Plumb 100% To Do

100% submission about 10/20
Reviews about 10/5

11 TYPICAL CORRIDOR PIPING ELEVATION DETAIL
N.T.S

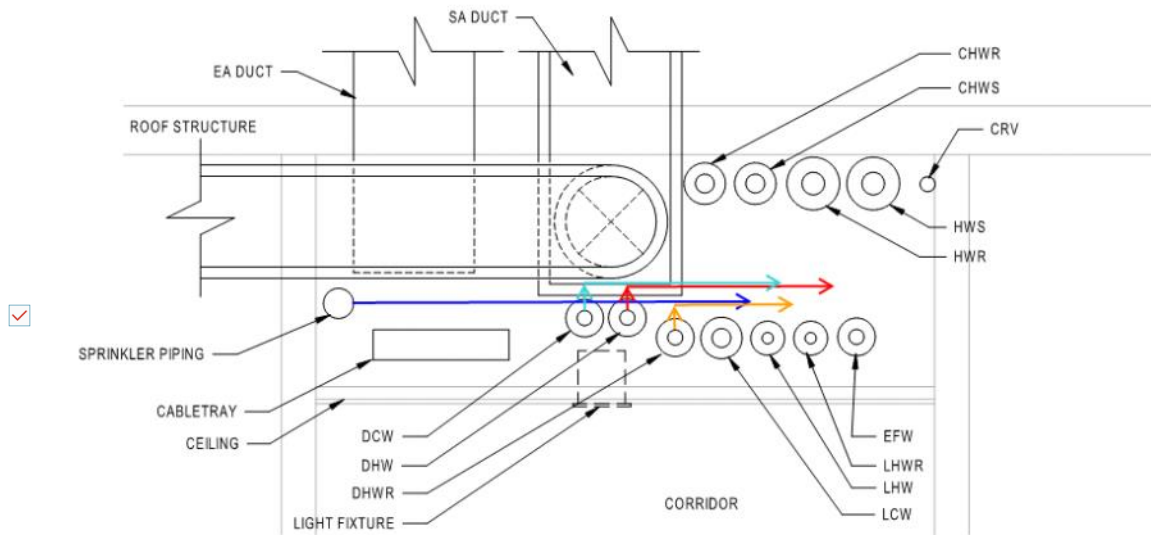
- ☒ Domestic and lab cold and hot water & recirc - Ian
- ☒ Emergency fixture water
- ☒ Sanitary and storm? NFG
- ☒ Coordinate crawl space piping with new architectural stem walls. Ian / Adi - Hot item
- ☒ Meat + potatoes - Adi/Ian
- ☒ Final check - and lab gases NFG
- ☒ Coordinate corridor ceiling. Right now we cannot connect branch piping and run it out to the adjacent spaces. See markup below. Ian
